1.0 APPLICATION SUMMARY

Applicant: Catholic Charities, Diocese of St. Petersburg
FLU Category: OC-20
Service Area: Urban
Site Acreage: 2.36 AC
Community Plan Area: Ruskin
Overlay: None

PRS 24-0013

2.5 Proposed Site Plan (partial provided below for size and orientation purposes. See Section 8.2 for full site plan)

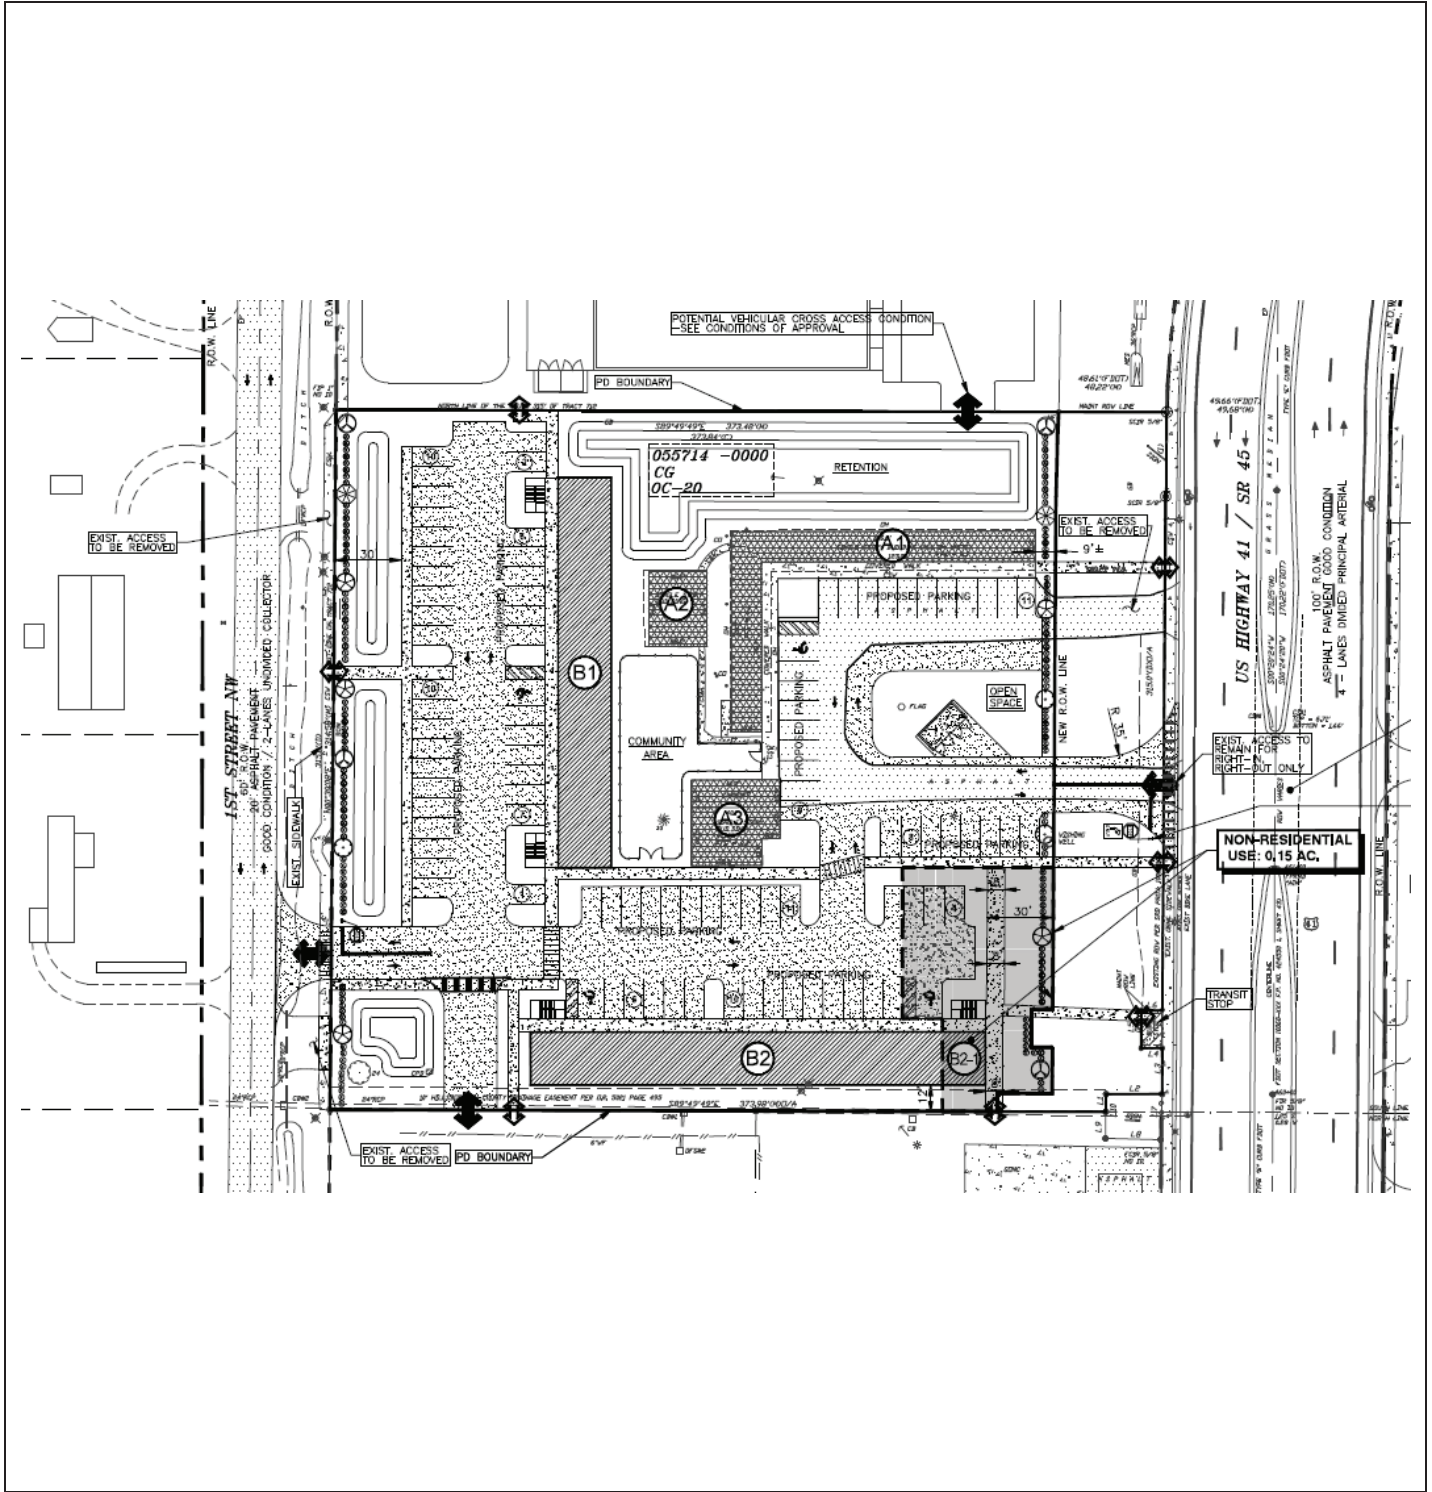
No changes to the permitted uses of the development have been proposed as part of this modification. The proposed modification to the building area will not intrude into the required setbacks, buffering, and does not entail a reduction of the required screening. Staff finds the proposed of permitted uses and to the site layout to be compatible with the surrounding areas.

The access relocation will have minimal impact on the transportation network. Transportation Review staff offered no objection to the proposed access points relocation, subject to the revised conditions as outlined in the conditions of approval.

- a) The land area for the residential uses shall be limited to ~~2.12~~ 2.26 acres. The area shall be restricted to a maximum of 6 Multi Family buildings and a laundromat for residents use.

- a) The area of the non-residential shall be a maximum of ~~0.24~~ 0.10 Acres.
 - b) Maximum square footage shall be as indicted in the development table in the General Site Plan.

**EXHIBIT
A**

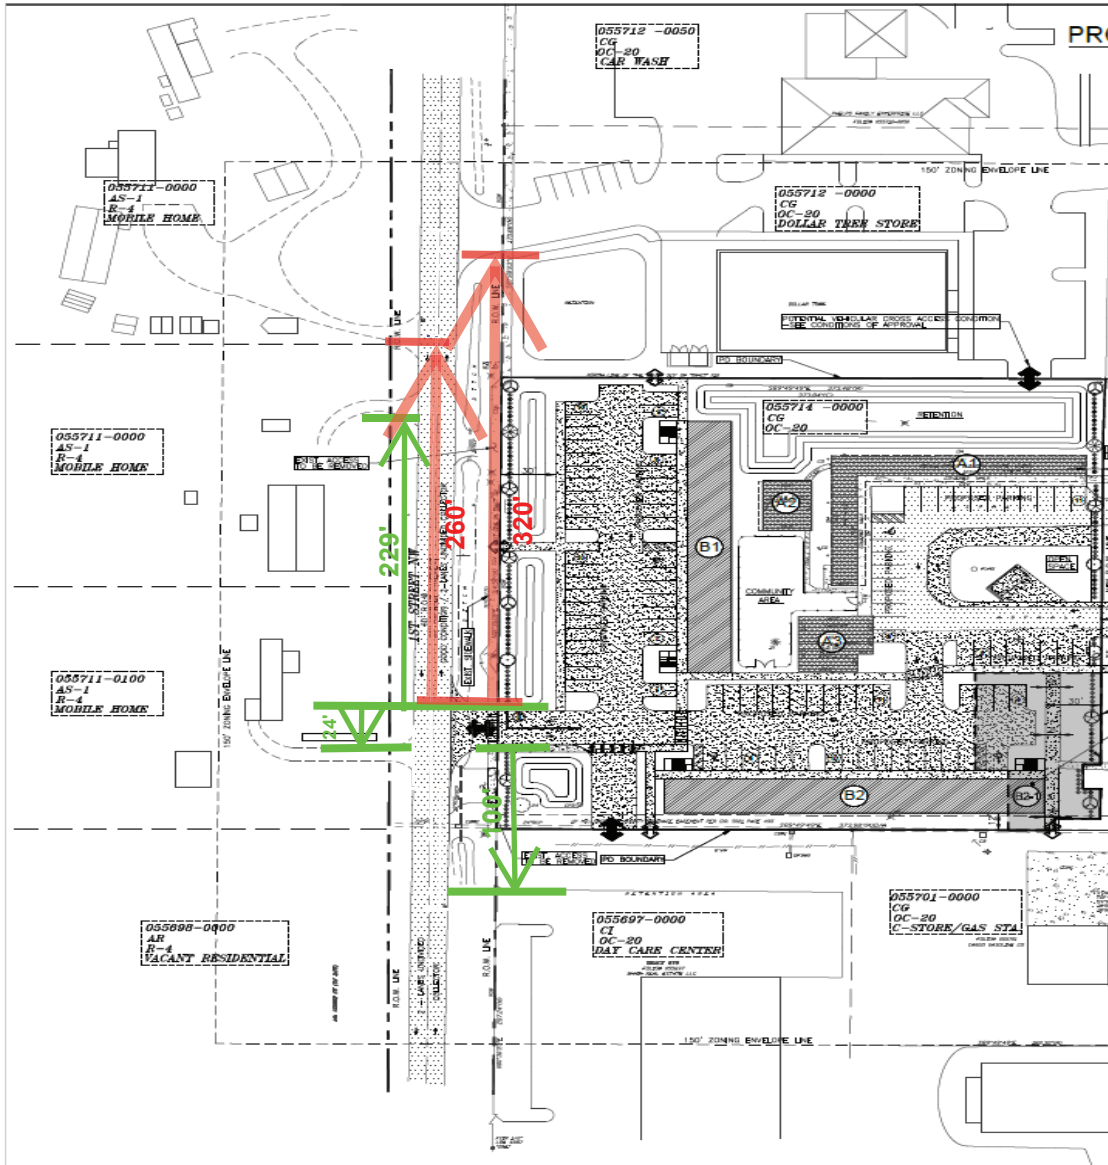
We are requesting an administrative variance to Land Development Code (LDC) Section 6.04.07 – Table: Minimum Spacing. According to the Hillsborough County Comprehensive Plan Functional Classification Map, 1st Street NW is classified as a Class 6 collector roadway and requires a 245 ft. minimum separation between driveways. The applicant is proposing a single full project access on 1st Street NW, approximately 70' from the southwest corner of the subject site. The proposed driveway is 100'± distance apart from the existing driveway to the south of the subject site; 229'± distance from the proposed driveway to the northwest of the site; and 24'± distance from the proposed driveway to the subject site across the street to the southwest. Thus, the proposed access on 1st Street NW does not meet the County Access Management Code.

- If PRS 24-0013 is approved, the County Engineer will approve a Sec. 6.04.02.B Administrative Variance (dated January 25, 2024) from the LDC Section 6.04.07 access spacing requirements, which has been found approvable by the County Engineer (on January 25, 2024). Approval of this Administrative Variance will permit the reduction of the minimum access spacing between the project driveway on 1st St. NW and the next closest connections as follows:

1. A variance of +/- 145 feet from the closest driveway to the south on the same (east) side of the roadway, resulting in an access spacing of +/- 100 ft.;

2. A variance of +/- 221 feet from the closest driveway to the south on the opposite (west) side of the roadway, resulting in an access spacing of +/- 24 ft; and,

3. A variance of +/- 16 feet from the closest driveway to the north on the opposite (west) side of the roadway, resulting in an access spacing of +/- 229 ft.
